Polaris Industries Inc.

SUBJECT: INCORRECT TIRE LOADING INFORMATION ON THE VIN DECAL

2006 Victory Vegas Jackpot & 2006 Ness Signature Series Vegas Jackpot

Safety Recall Notice 06V-xxx

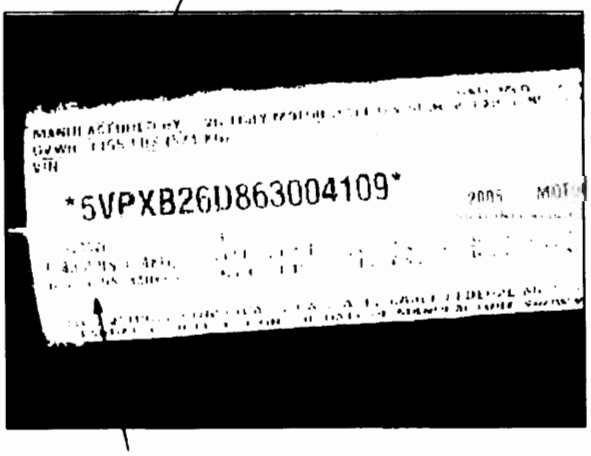
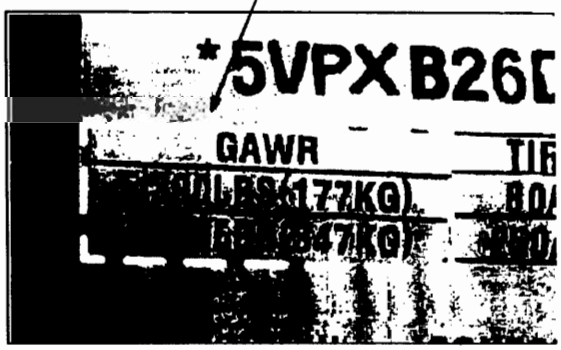
The reason for this recall:
On the affected motorcycles, the Vehicle Identification Number (VIN) decal located on the left front down-tube of the motorcycle frame incorrectly lists the GAWR (Gross Axle Weight Rating) for the front axle as 405 pounds. The correct GAWR for the front axle is 390 pounds. Reliance on the incorrect data may lead to overloading of the front tire which could result in a tire blow out causing sudden loss of vehicle control and possibly a crash.

Incorrect: F: 405 LBS (184KG)
R: 750 LBS (340KG)

Correct: F: 390 LBS (177KG)
R: 763 LBS (347KG)

1. Clean the decal with warm soapy water to remove all oil, grease or dirt.
2. Rinse with clear water.
3. Dry decal and surrounding area thoroughly.
4. Carefully remove the new GAWR decal at right and apply it over the GAWR area of the decal on the motorcycle as shown. Be sure all previous GAWR information is covered, and press the decal firmly in place.

Apply this decal over the GAWR portion of the VIN decal on the motorcycle.
